Response to AR1/TR4; Nix Sand and Gravel Mine: M2001046

Subject: Response to Adequacy Review for Technical Revision, Nix Sand & Gravel Mine (M-

2001-046), concerning changes related to address and water-related practices

This response addresses comments from DRMS regarding Reclamation Permit No. M-2001-046 in its Adequacy Review for Technical Revision #4:

Revised Figure 2 (well information) from Sampling and Analysis Plan

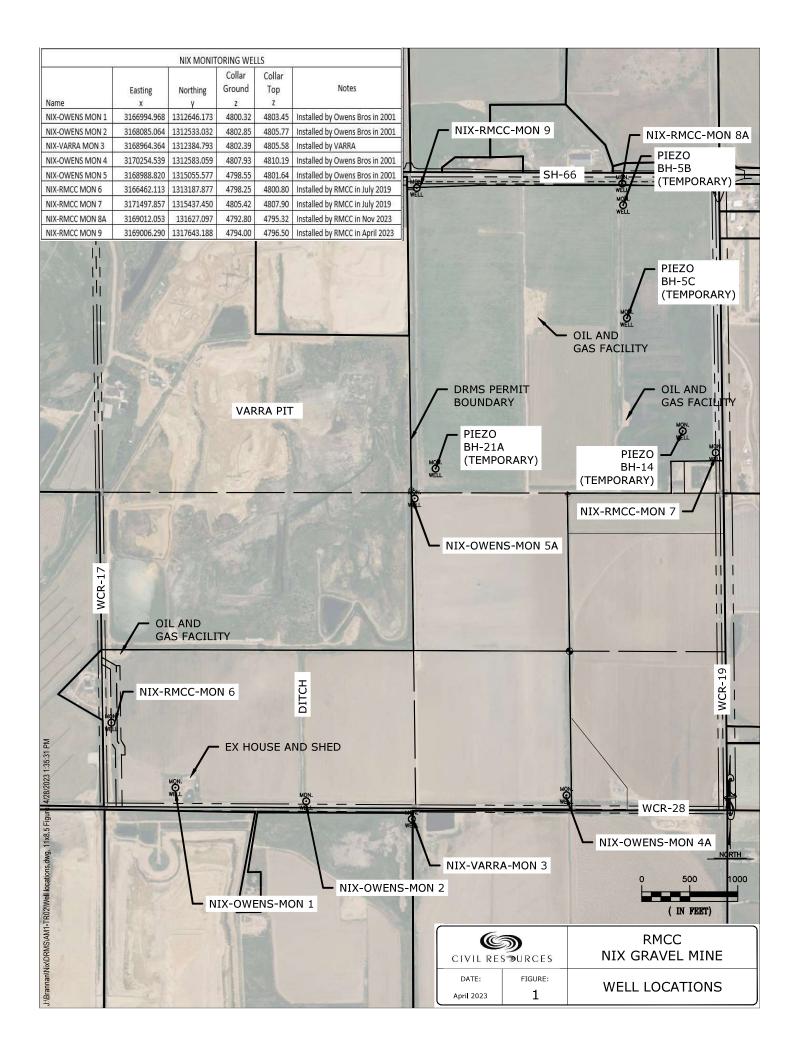
- 1. New address. Acknowledged.
- 2. Information for monitoring wells 8 and 8A. The abandonment report for Mon-8 and the construction report for Mon-8A are attached. Figure 2 in the 2023 Sampling and Analysis Plan ("Plan") has been updated to include Mon-8A details on the map and inset (attached). Table 2 in the Plan has been revised to incorporate Mon-8A as shown below:
